Project	IEEE 802.16 Broadband Wireless Access Working Group < http://ieee802.org/16 >	
Title	Comparison of 64QAM and 16QAM blocking signals for Adjacent and Non-adjacent Channel rejection	
Date Submitted	2006-09-26	
Source(s)	Darcy Poulin SiGe Semiconductor	Voice: +613-820-9244 x274 dp@sige.com
Re:		
Abstract	This document explains why the difference in ACR between 16QAM-3/4 and 64QAM-3/4 should be the same as the difference in SNR between 16QAM-3/4 and 64QAM-3/4	
Purpose	To explain how ACR should be related to SNR.	
Notice	This document has been prepared to assist IEEE 802.16. It is offered as a basis for discussion and is not binding on the contributing individual(s) or organization(s). The material in this document is subject to change in form and content after further study. The contributor(s) reserve(s) the right to add, amend or withdraw material contained herein.	
Release	The contributor grants a free, irrevocable license to the IEEE to incorporate material contained in this contribution, and any modifications thereof, in the creation of an IEEE Standards publication; to copyright in the IEEE's name any IEEE Standards publication even though it may include portions of this c

64QAM-3/4 Blocker

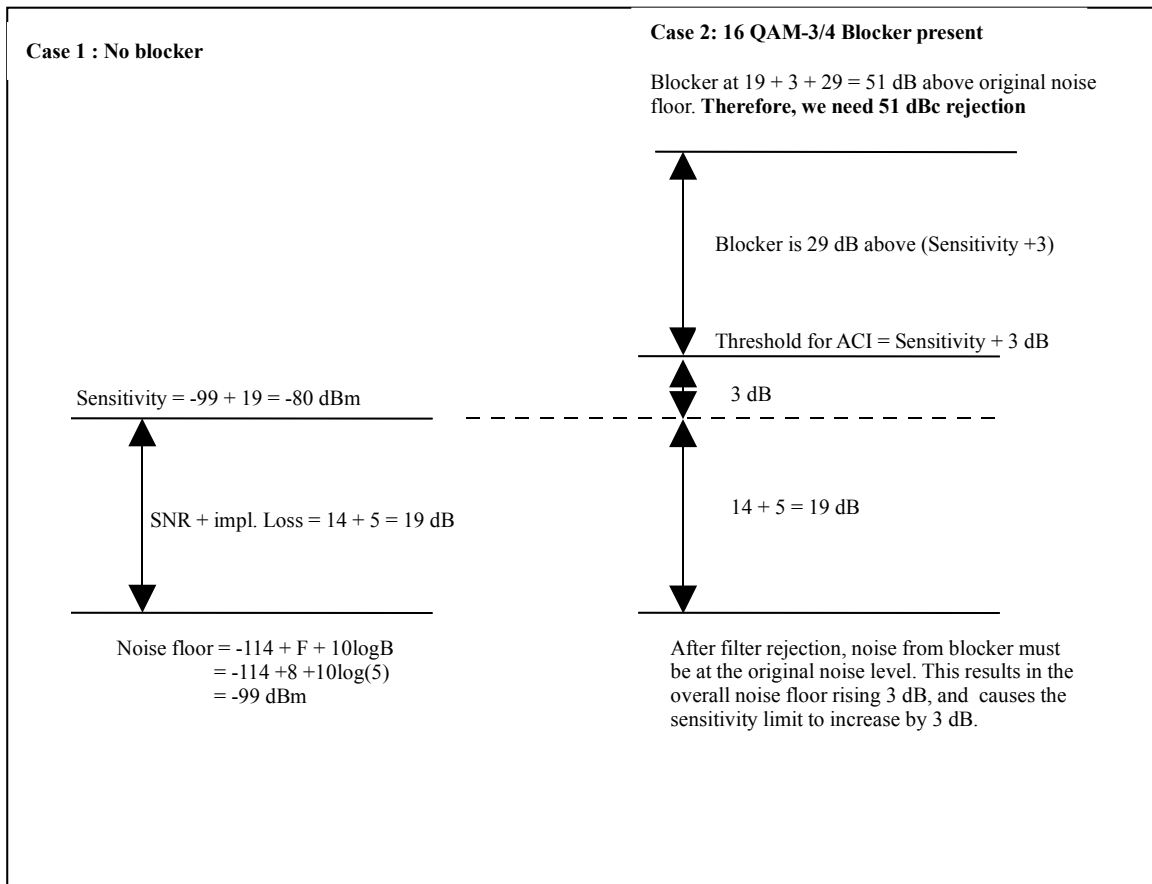
With no blockers present, the sensitivity is 25 dB above the thermal noise floor.

When a blocker is present, the specification requires us to start measuring performance 3 dB above the original rate-determined sensitivity. Therefore, noise from the blocker must result in the noise floor increasing by 3 dB. In order to cause a 3 dB increase in the noise floor, the noise from the blocker must fall at the original noise floor level. Filtering in the radio must therefore suppress the blocking signal to the level of the original noise floor. This information allows us to determine how much rejection the radio must provide to guarantee that the blocking specification can be met.

Since the blocker for 64QAM is 23 dB above the desired signal, and since the noise from the blocker must be reduced so that it is at the original noise level, we will require $23 + 3 + 25 = 51$ dBc filtering.
